REQUEST

Current Zoning: I-1(CD), light industrial, conditional
Proposed Zoning: I-1(CD) SPA, light industrial, conditional, site plan amendment with five-year vested rights

SUMMARY OF PETITION

The petition proposes to allow the development of a vacant parcel for a hotel with 200 rooms or 75,000 square feet of office uses.

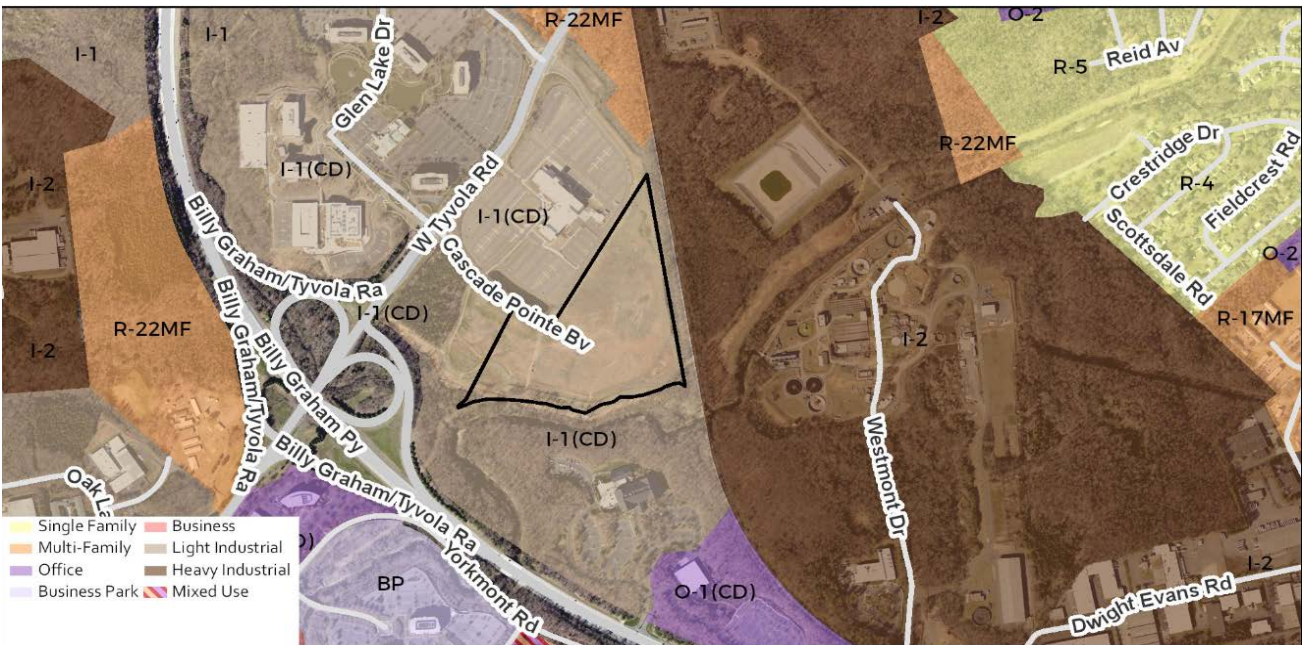
1. Provide building elevation along Cascade Pointe Boulevard and label building materials on all elevations.
2. Show and label the:
 - width of proposed sidewalk connection to Cascade Pointe Boulevard.

- width of new planting strip and sidewalk along the new public street.
3. Clarify if the site can have an office building or office uses.
4. Modify and clarify Note 6.A under Architectural Standards to read "all sides of the building will be articulated with doors and windows toward the public or private streets".

5. Modify and clarify note 6.D under Architectural Standards that "Direct pedestrian connections shall be provided from street facing doors with architectural features".

6. Modify and clarify note 6.G under Architectural Standards that "buildings will be a minimum height of 22 feet".
7. Modify and clarify note 6.H under Architectural Standards that "multi-story buildings will have a minimum of 20 percent transparency on all upper stories."
